Office Action Summary	Application No. 10/595,355	Applicant(s) ARAI ET AL.	
	Examiner Edmund C. Kang	Art Unit 2885

DETAILED ACTION

5. Claims 1-3 are rejected under 35 U.S.C. 102(b) as being anticipated by Pelka (US 6,007,209).

7. Claims 1-4 are rejected under 35 U.S.C. 103(a) as being unpatentable over Watanabe (JP 10-134619) in view of GC Corp (JP 2001-195904).

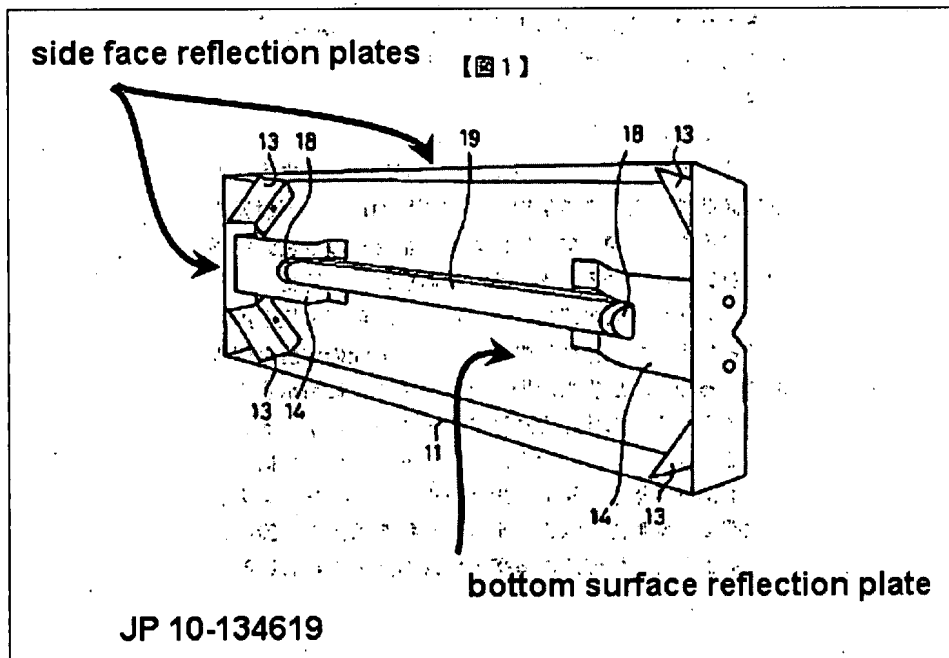
wherein the reflection plate is composed of a bottom surface reflection plate (see annotated Fig. 1 below) for reflecting, from the bottom surface direction, rays of light emitted from the light source unit, side face reflection plates (annotated Fig. 1) for reflecting rays of light emitted from respective forward and backward, and left and right side surface directions, and corner reflection plates (Figs. 1-3, **13**) for covering respective corner portions where the bottom surface reflection plate and the side surface reflection plates are connected.
